WOLF CREEK GENERATING STATION, UNIT NO. 1
ENVIRONMENTAL REPORT OPERATING LICENSE STAGE

REVISION 2
INSTRUCTIONS FOR INSERTING REVISION 2

Figure 240.14/240.15 - 1
Flood Prone Area Before
Construction of WCGS and
Facilities

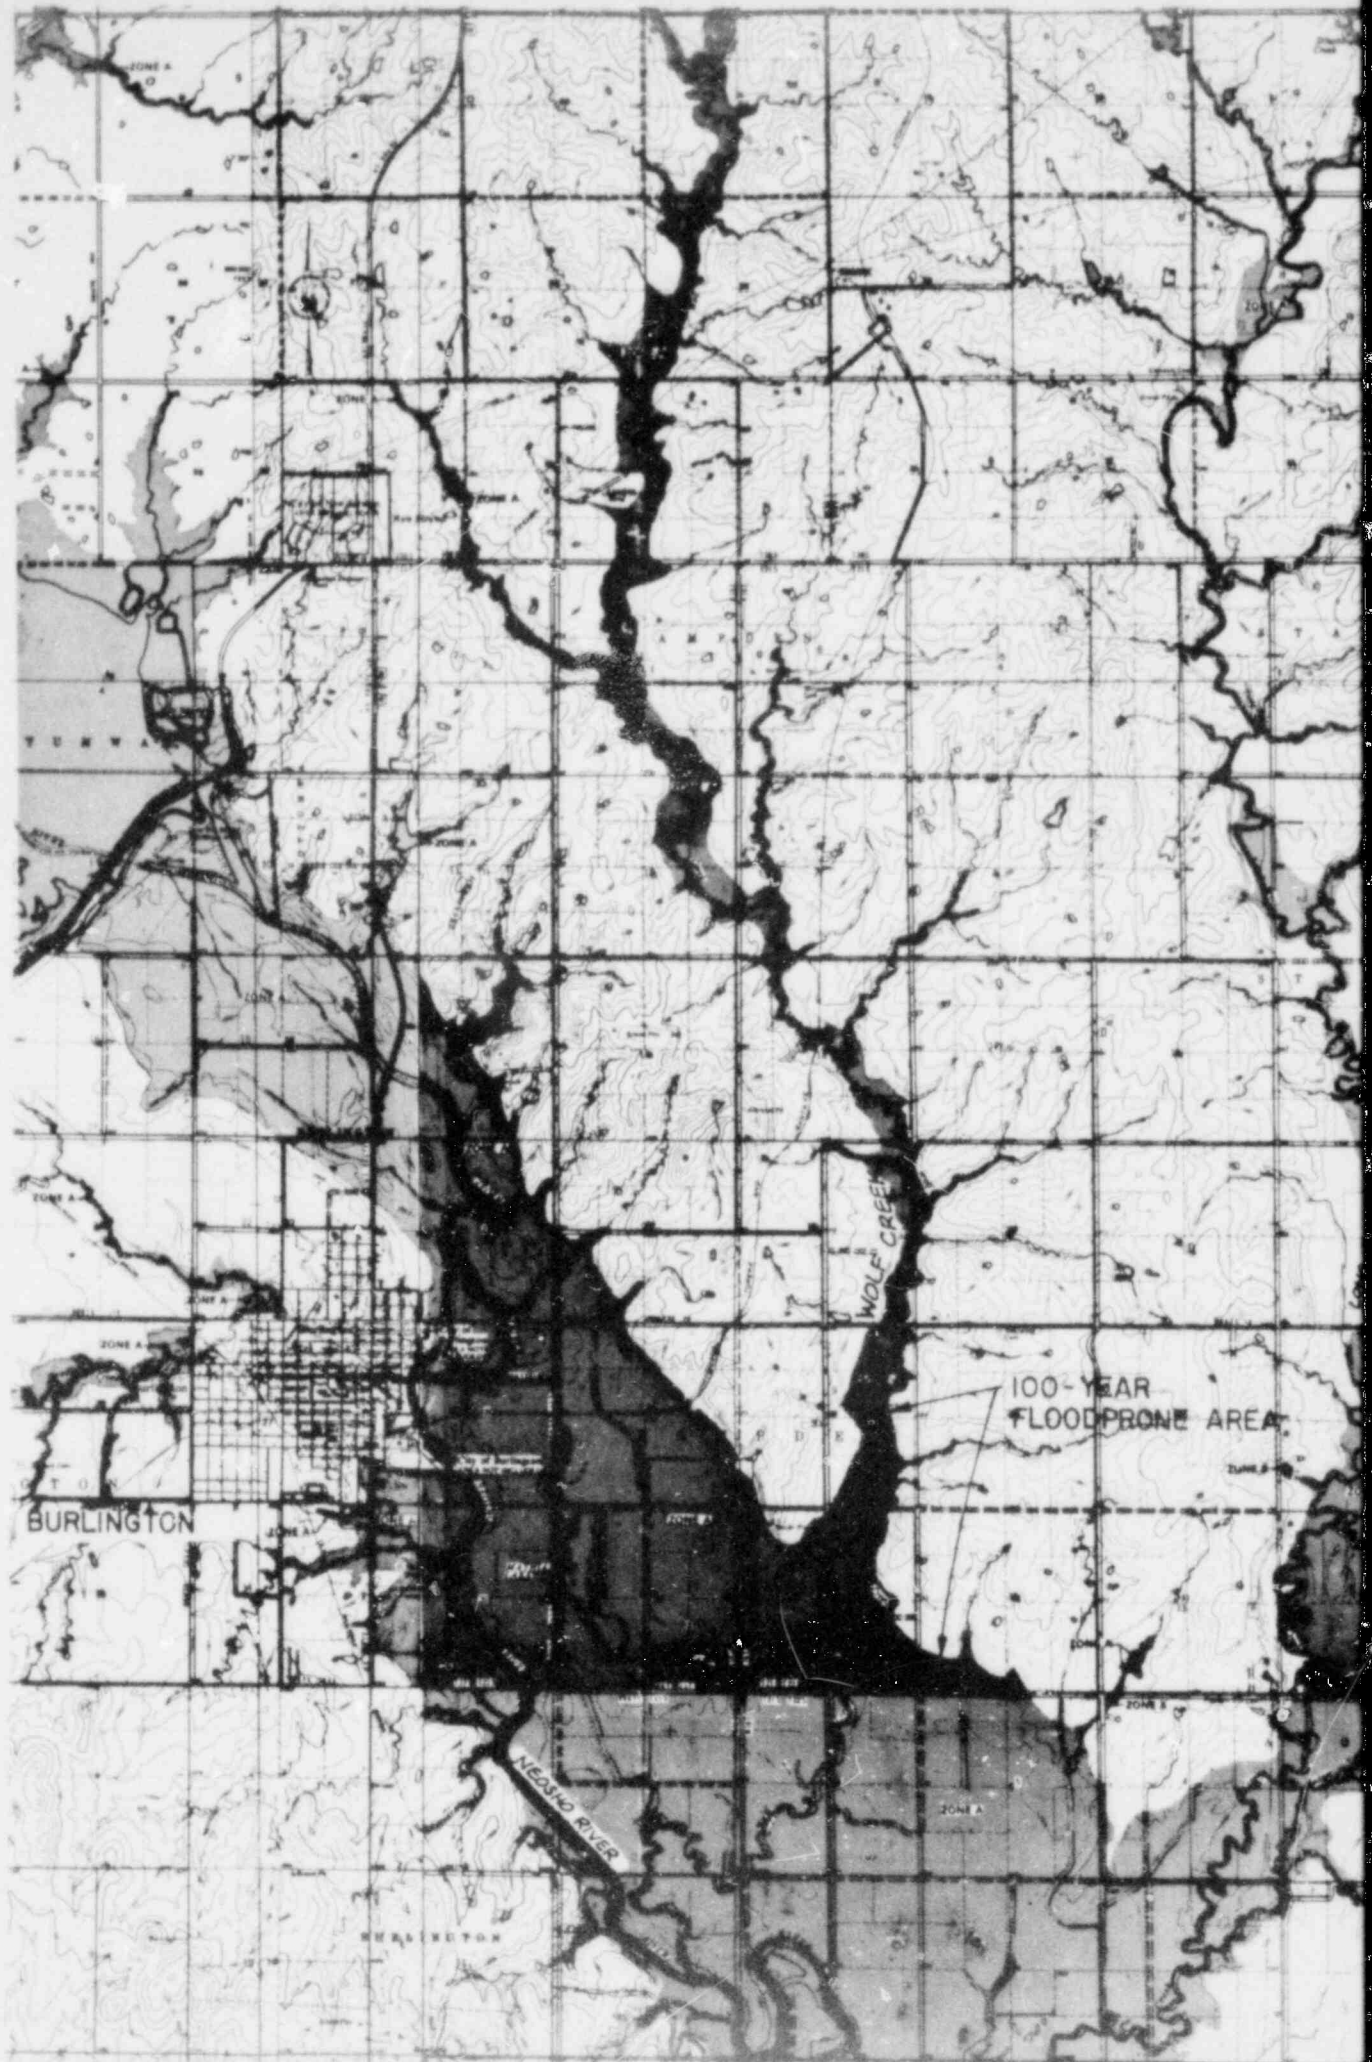
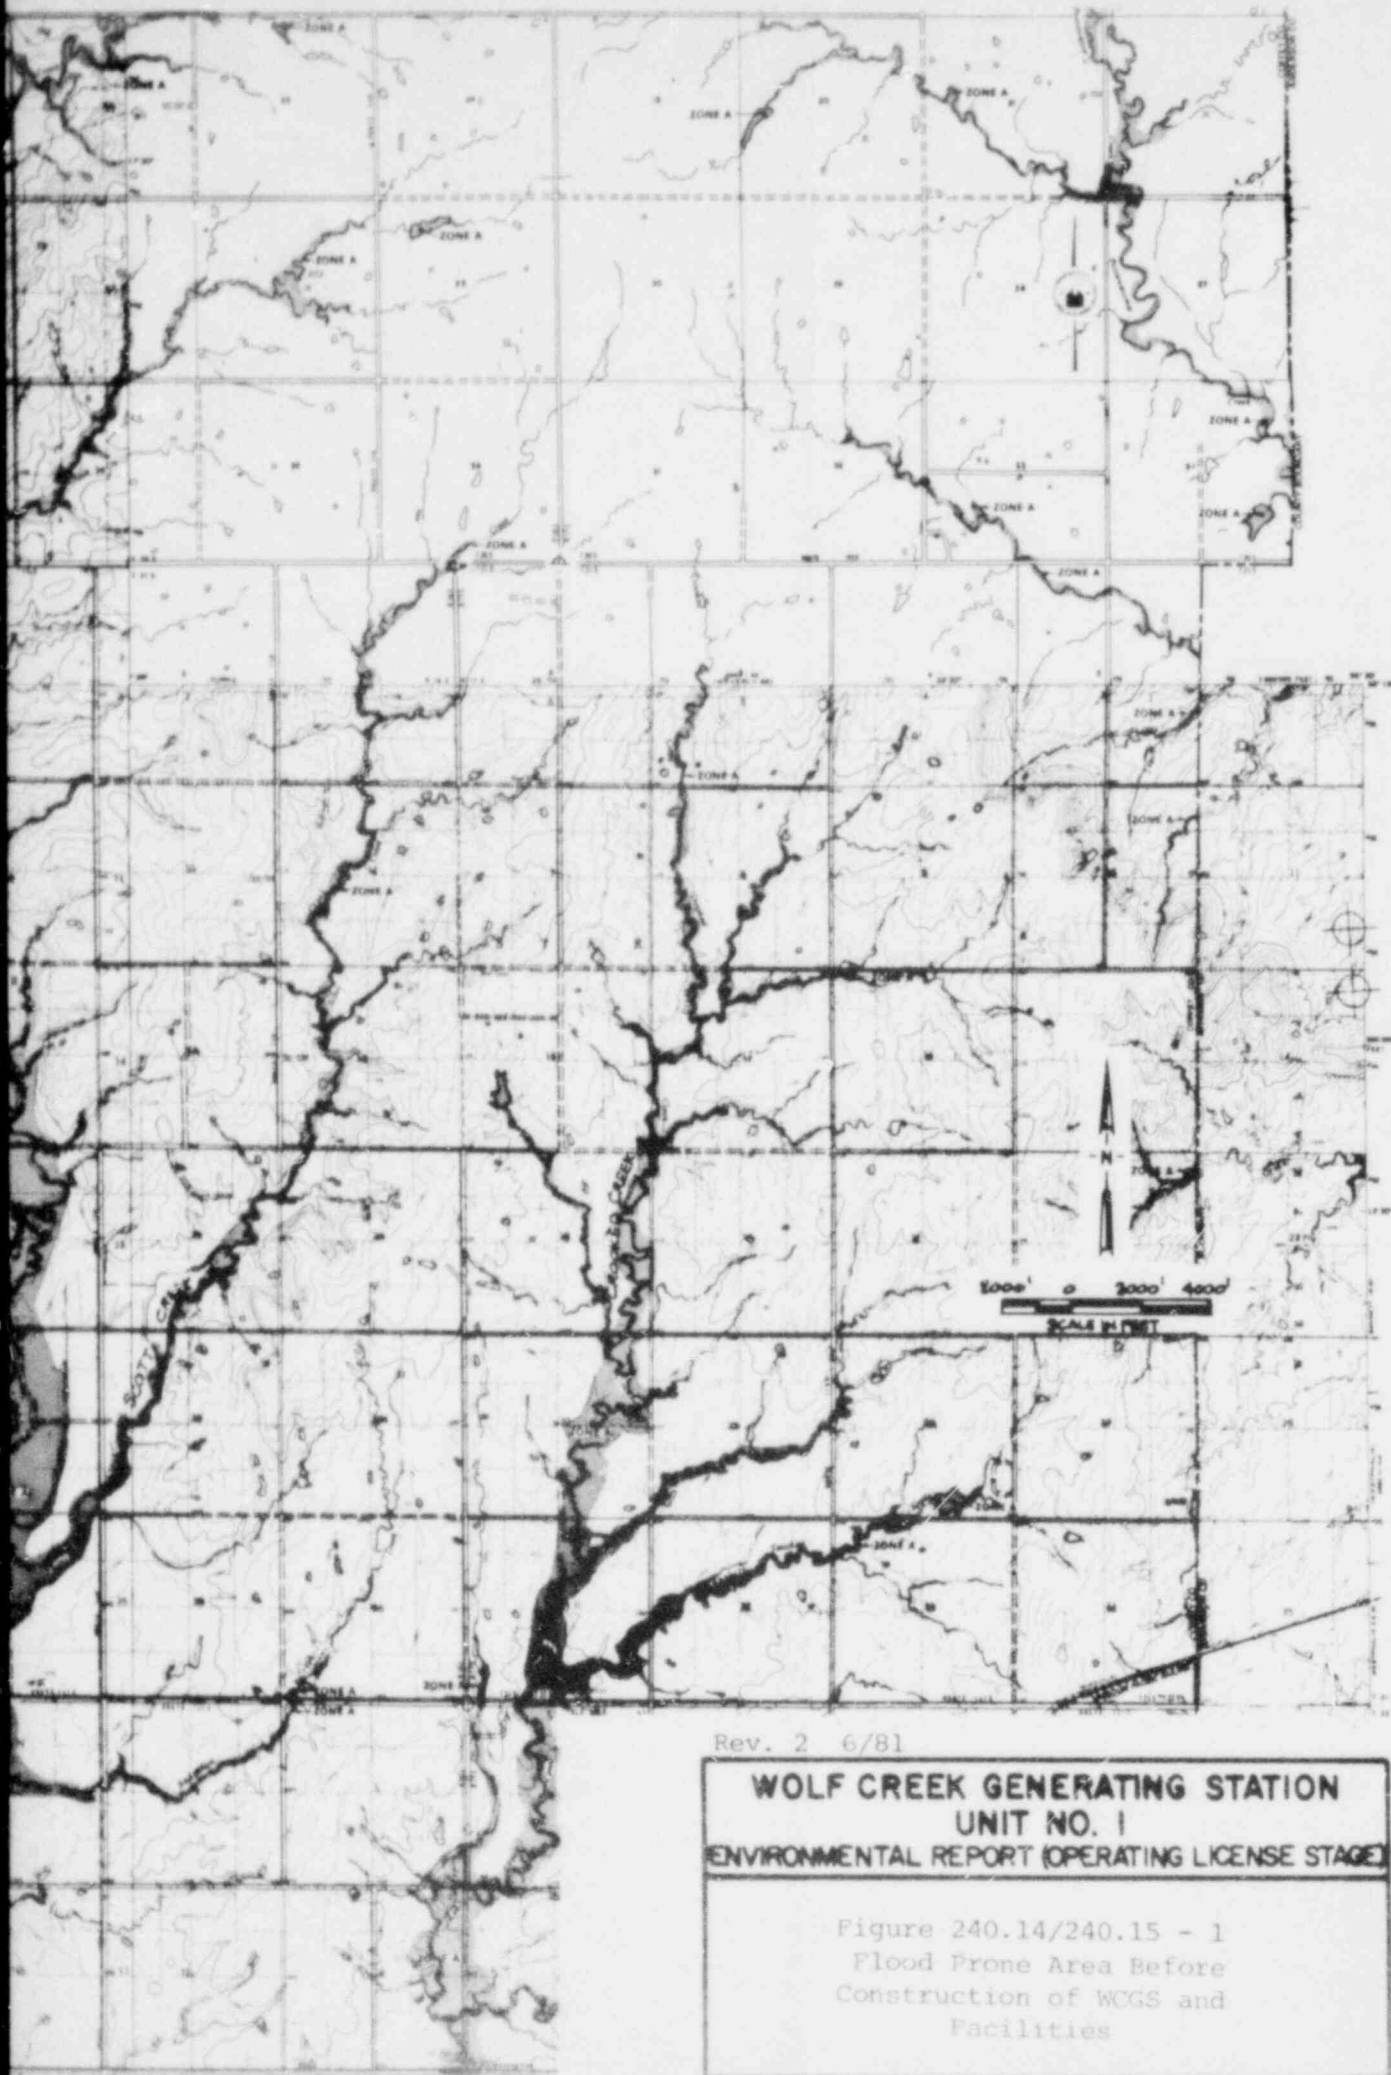
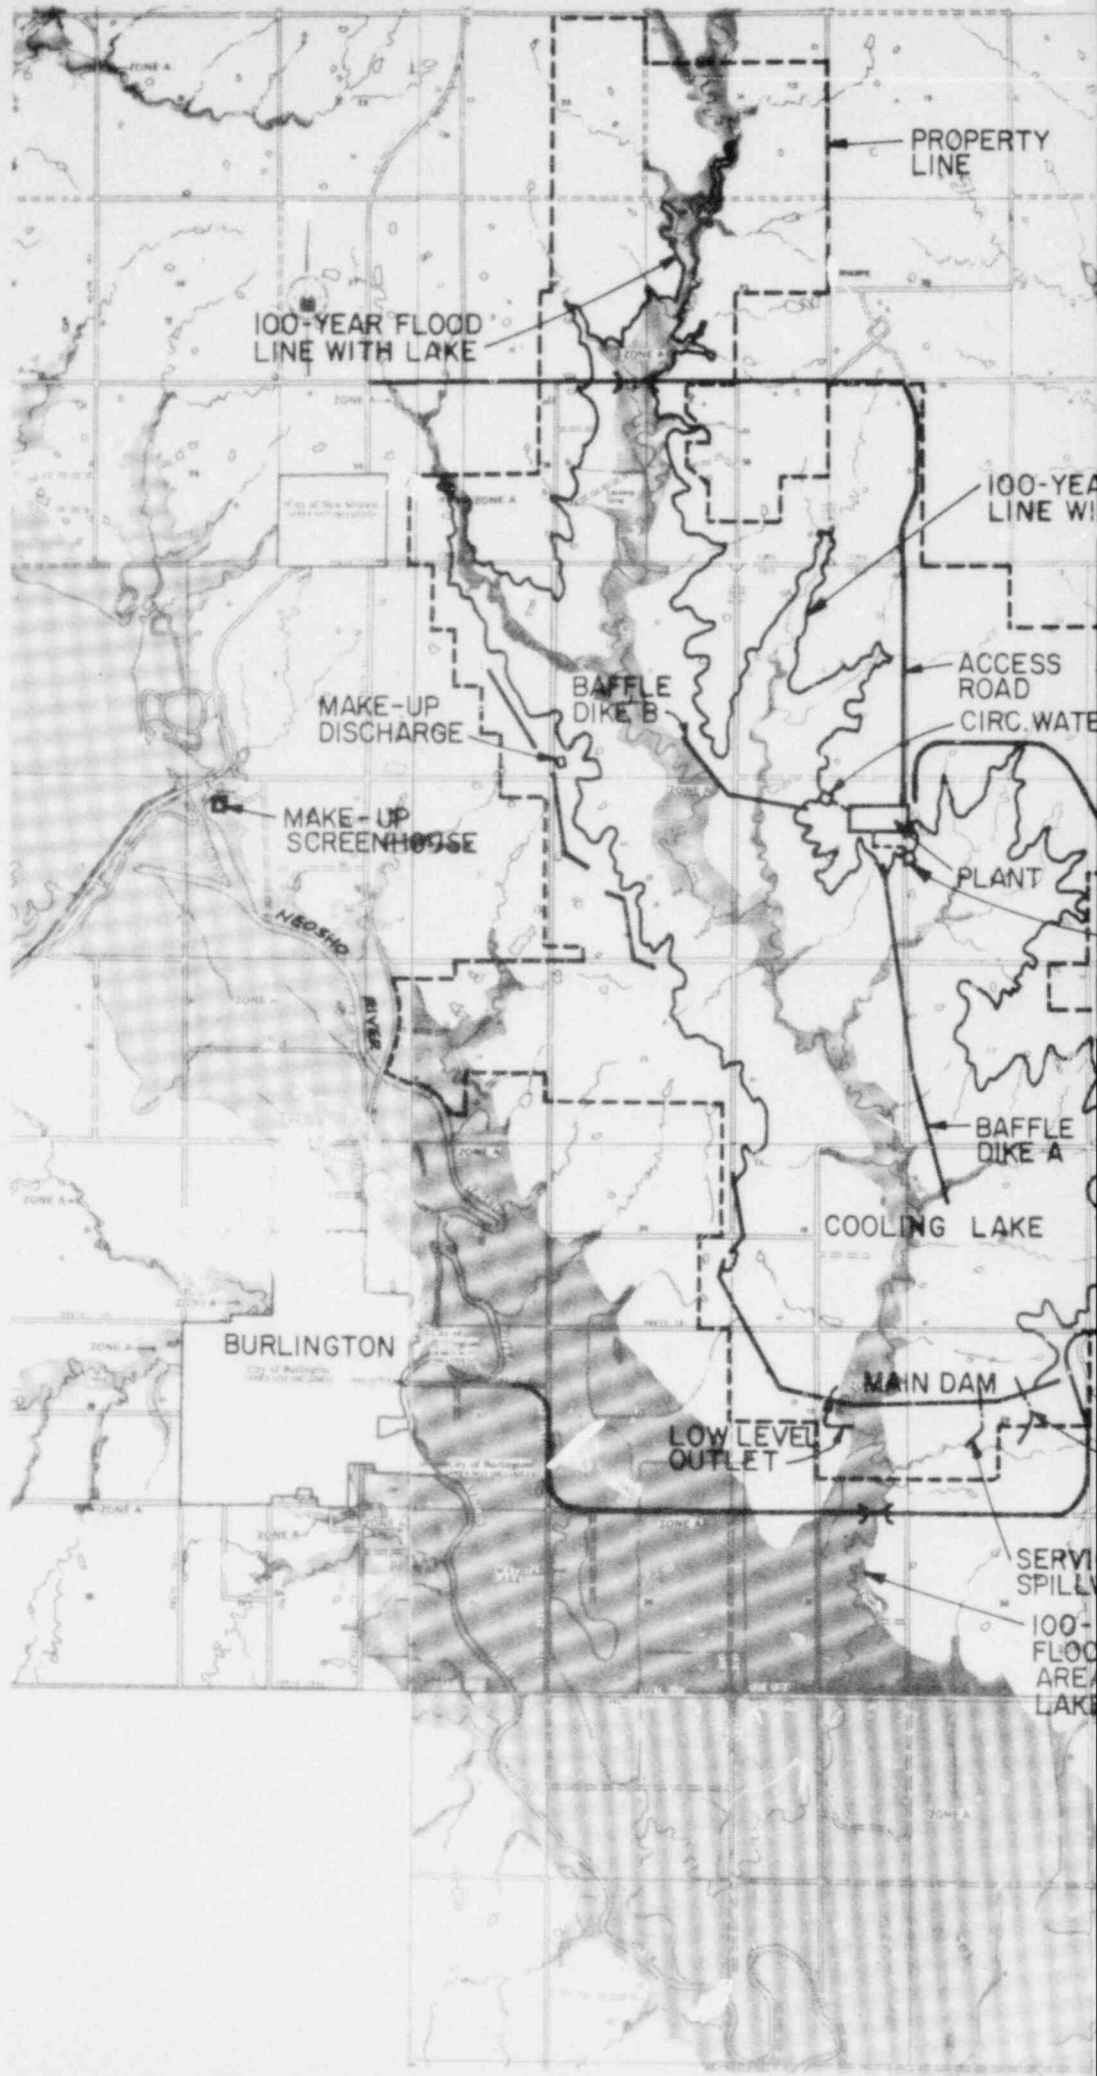
- Q240.15 a. Discuss the hydrologic effects of all items (ER) identified in response to question 14c. Discuss (5.7) the alteration in flood flows in Wolf Creek below Wolf Creek Cooling Lake. Determine the effect of the cooling lake on the 50, 10, 1, and .2 percent chance floods (2 year, 10 year, 100 year, and 500 year floods) in Wolf Creek below the cooling lake. Expected reservoir water level and storage and the time of the storm should be taken into account.
- b. Provide details of your analysis used in response to a. above.

The flood prone area, the area flooded due to a 100-year flood, in the vicinity of the site prior to the construction of the WCGS and its facilities is shown in Figure 240.14/240.15-1. The flood prone area is taken from Flood Hazard Boundary Maps for Coffey County, developed by the Federal Insurance Administration, U.S. Department of Housing and Urban Development, dated August 1977. Maps showing the area flooded by a 500-year flood are not developed by the FIA and, hence, are not available. However, a Standard Project Flood (SPF) was developed for the Wolf Creek cooling lake and is presented below.

A cooling lake was developed for WCGS by constructing a dam across Wolf Creek. The 100-year flood level in the cooling lake is estimated to be 1089.8 MSL. The flood prone areas above the dam due to a 100-year flood before and after the construction of the dam are shown in Figure 240.14/240.15-2. The boundaries of the property owned by the applicant are also shown in Figure 240.14/240.15-2. The area covered by the 100-year flood in the cooling lake is well within the property boundaries (Figure 240.14/240.15-2). Beyond the property boundary in the upper reaches of Wolf Creek, the 100-year flood in the cooling lake does
